ADDENDUM NO. 1

Plans & Specifications for: Elsie Turner Field & Graverson Playground, Waltham, MA

In accordance with documents prepared by: Carolyn Cooney & Associates

DWG No. **ES.1A**

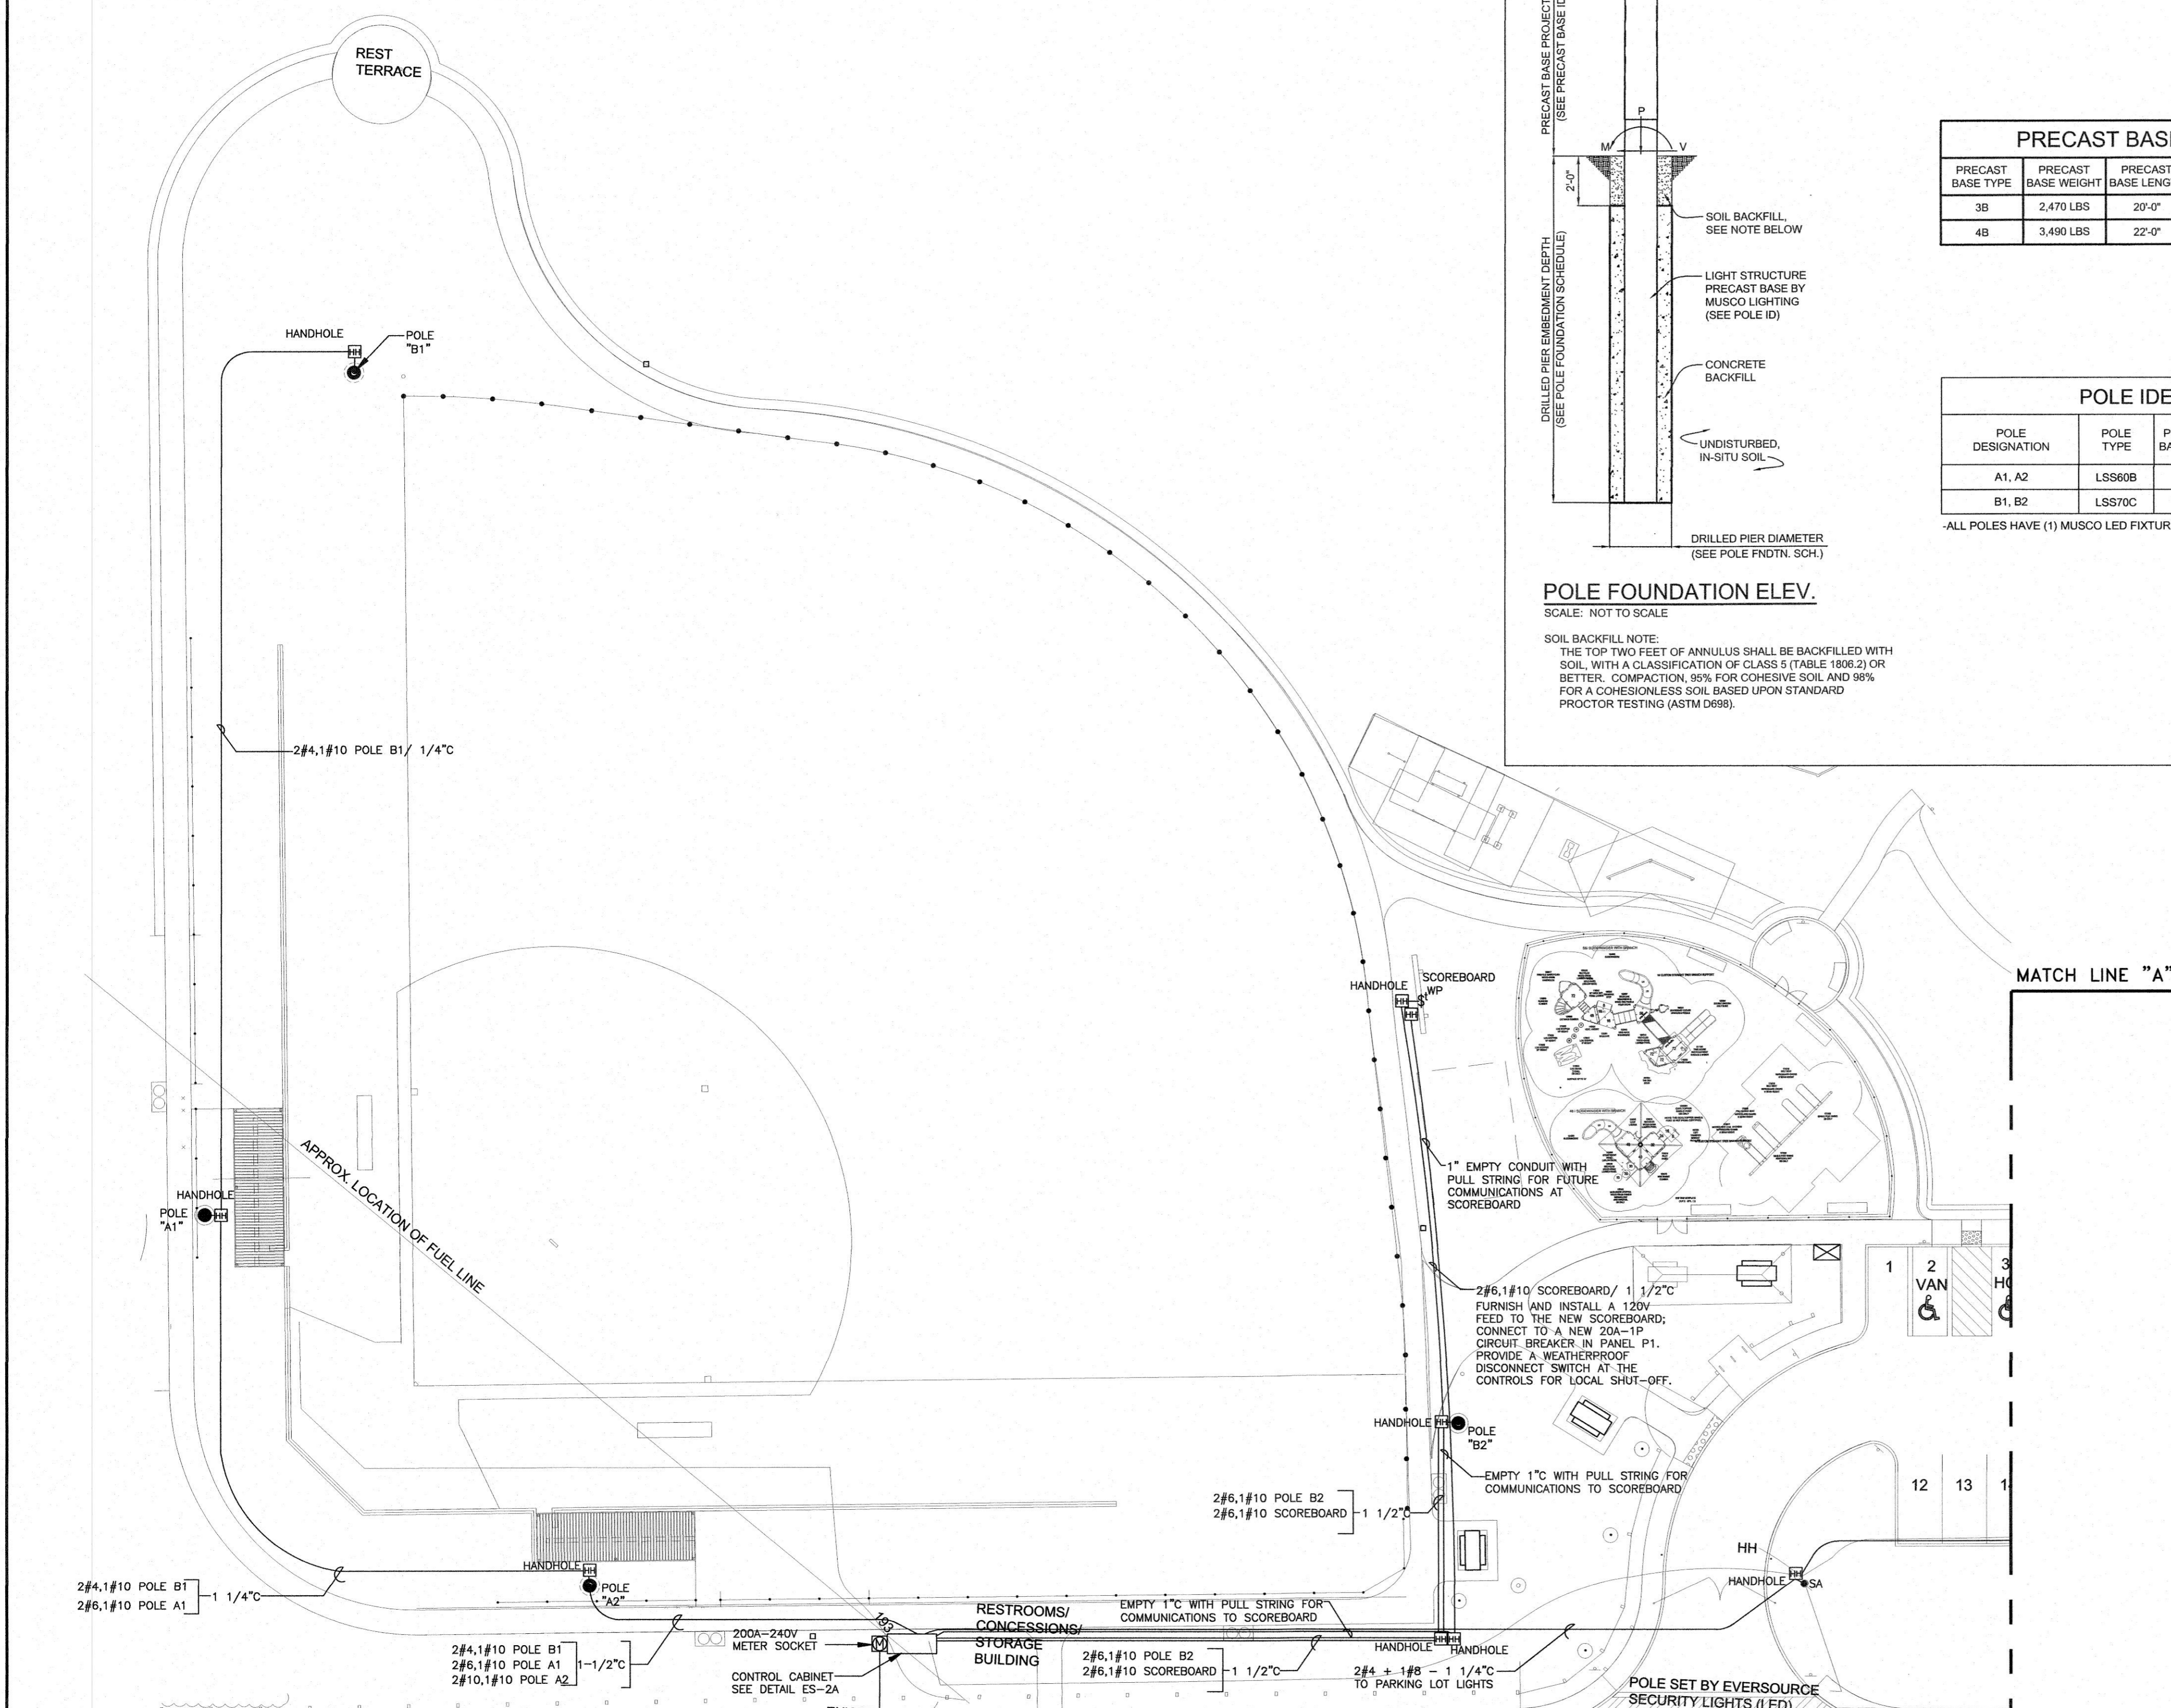
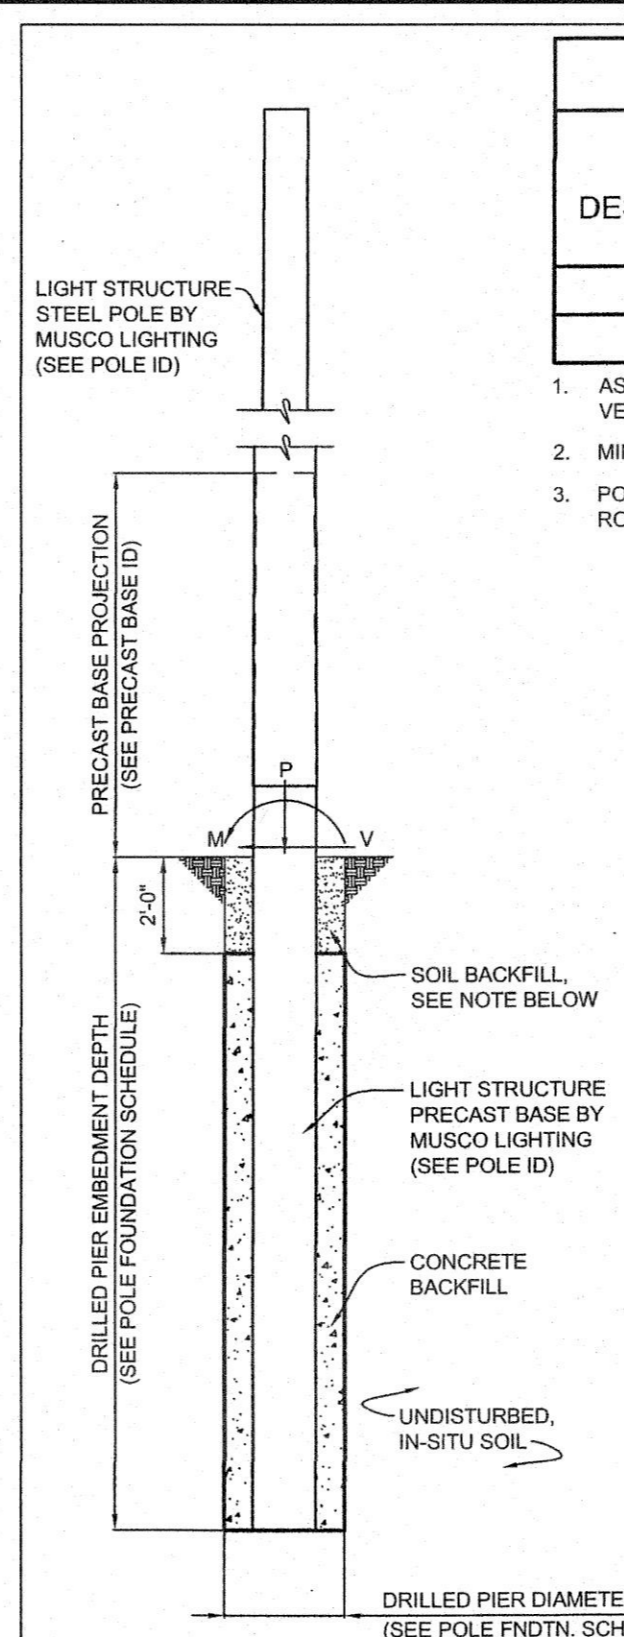
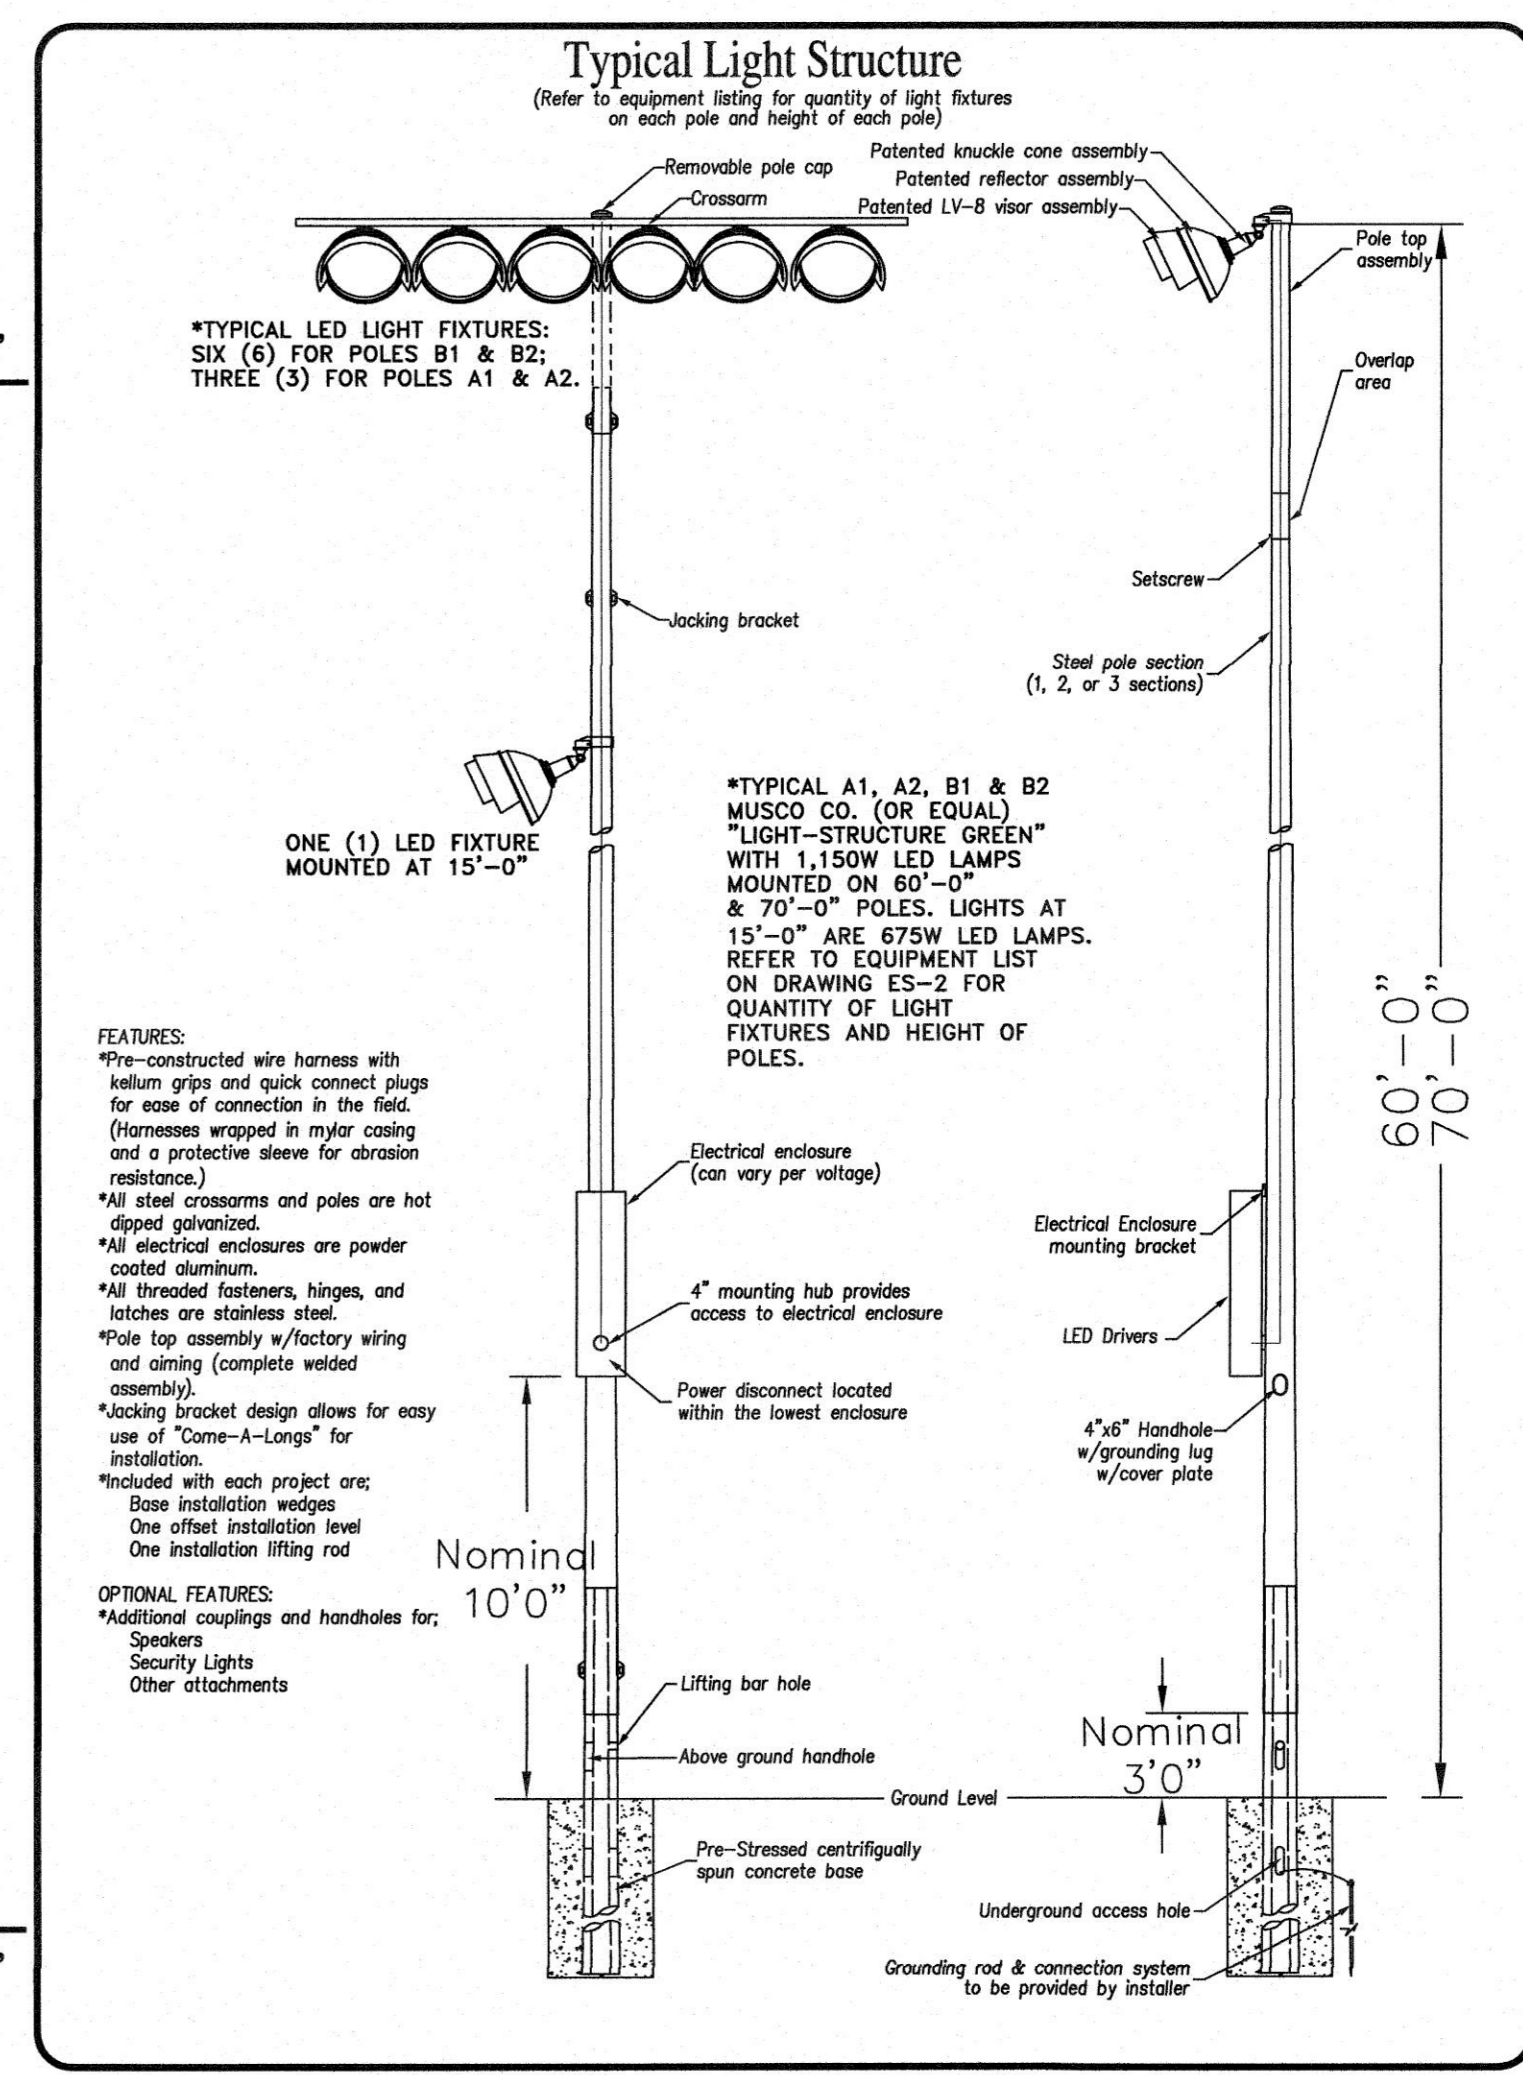
- ITEM NO. 24** *Elsie Turner Field: Replace Drawing L.614 with new drawing L.614 attached.
Revision is to delete a portion of chain link fencing at dugouts.*
- ITEM NO. 25** *Elsie Turner Field: Add new drawing L.624, attached.*
- ITEM NO. 26** *Elsie Turner Field: Replace Drawing ES.1A with new Drawing ES.1A attached.
Revision is to number of light fixtures.*
- ITEM NO. 27** *Elsie Turner Field: Replace Drawing ES.2 with new Drawing ES.2 attached.
Revision is to number of light fixtures, and correction to Control Cabinet Detail connections.*
